24.0064 BB Revised Presentation 232 Clarendon St. Boston, MA 02116

Centry 21 Cityside

Revised Presentation

Railings

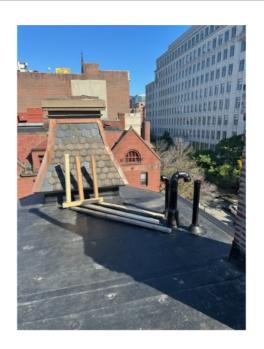
- Railings set back 12" from chimneys
- Previous mock up was against chimneys

Pipe Group B Chimnies Option 2

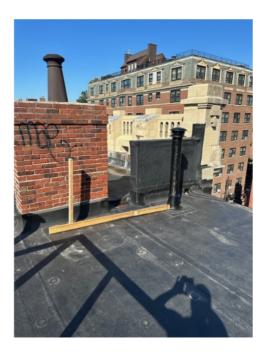
- A Second option is to install one (1) stainless steel Chimney cap on the front chimney and redirect the pipes on two (2) rear chimnies 90 degrees
- Pipes on rear two chimnies would point towards roof of 232 Clarendon
- Stainless steel chimney cap and pipes could be painted black

Pipe C

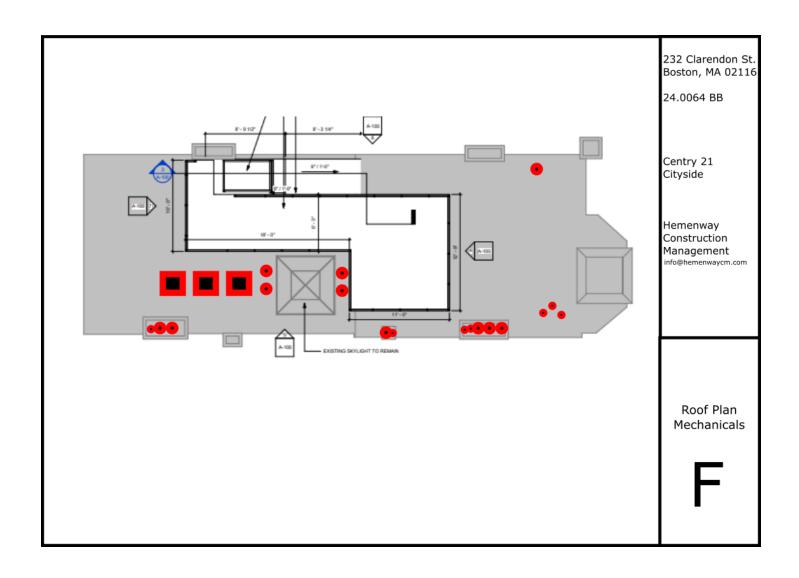
- Proposed move of this pipe
- See street view photos for visibility
- Would remain black pipes
